THE PARK MIRAMAR - MPC PHASE VI
(SITE PLAN APPLICATION NO. 2302288)

Architectural Design Summary

City of Miramar
Building, Planning & Zoning Department
Development Review Report – Variance

Application: 2307653 – Minimum Lot Frontage Variance

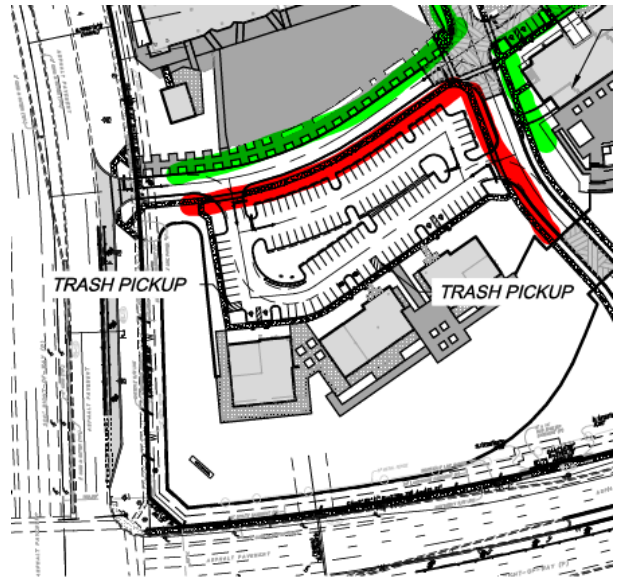
While the C-4 cluster does not meet this requirement, the proposed design of the space incorporates a lake amenity that affords opportunities for desirable views for the residents and users of the respective buildings.

Staff's Evaluation: The C-4 buildings, specifically C-4.2, C-4.3, and C-4.4, are located by the corner of the intersection of Miramar Parkway and Red Road, both of which are major arterial roadways. These buildings are intended to serve as a focal point of the project corner feature, which is a lake that will have dancing fountains and a large project sign. Purposefully, the dedicated placement of the C-4 buildings will also serve to hide the abutting parking lot from a portion of Red Road and most of Miramar Parkway. While the buildings do not meet the 0 to 30 feet requirement of the Code, the buildings integrate well with the overall urban design of the development. These buildings, which are programmed to become restaurants, will have large walkways connecting to other areas of the development, will have decorative urban elements (e.g. landscaping and benches overlooking the lake), and will have an architectural building design consistent with the overall architectural motif of the Park mixed-use development.

Figure 1. M.1 digital media display on the south façade.

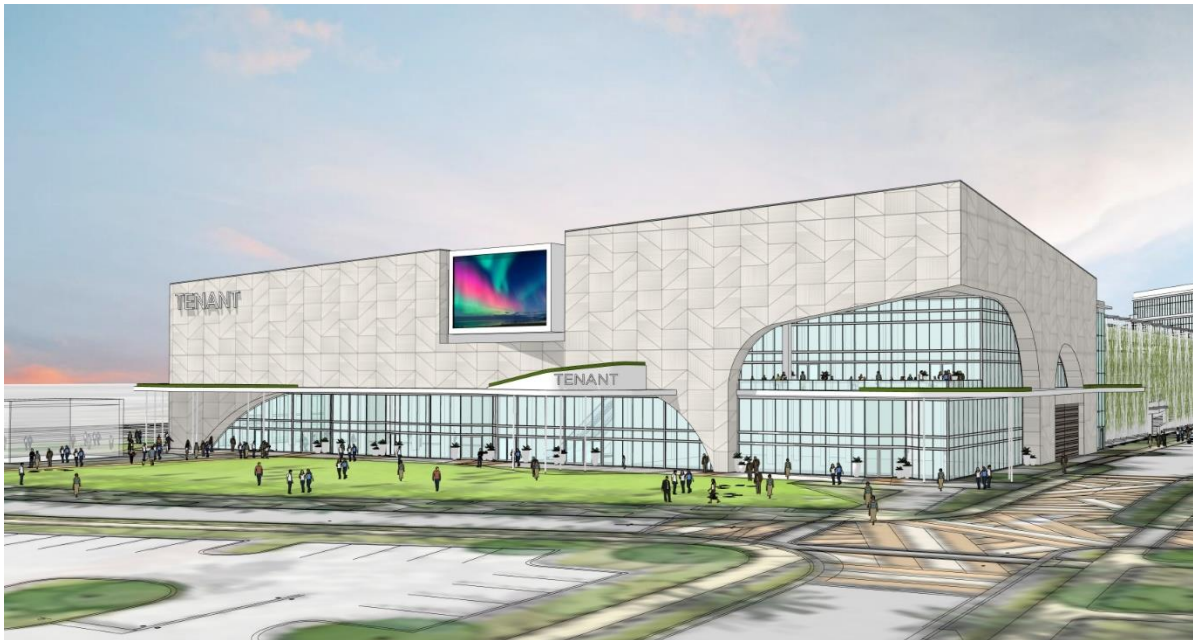
Applicant's Response: The size of the two digital displays is 1,000 and 493 square feet, respectively. The digital displays exceed the wall sign maximum size but do not exceed the freestanding sign maximum size. The 493-square-foot sign is far below the freestanding sign size threshold and exceeds the wall sign threshold only by 64 percent.

The digital media displays are not envisioned in the existing Miramar sign code and are not one of the sign types listed in *Table 1, Permanent Signage* (Code Section 1007). While the digital displays are mounted on a building and are technically ‘wall signs’, they could also be freestanding while keeping the same functionality. Furthermore, the maximum size limits in the Code are not designed for digital media displays and are inappropriate for them.

Figure 2. M.2 digital media display on the north façade.

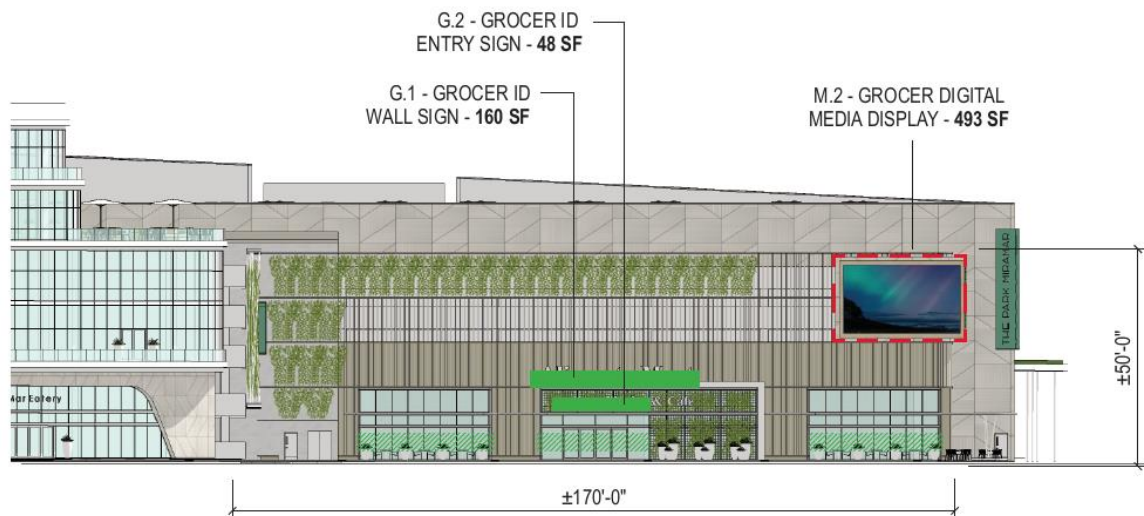
The digital displays were also designed to be proportional to the size of the façade; they constitute approximately 4-5 percent of their respective facades.
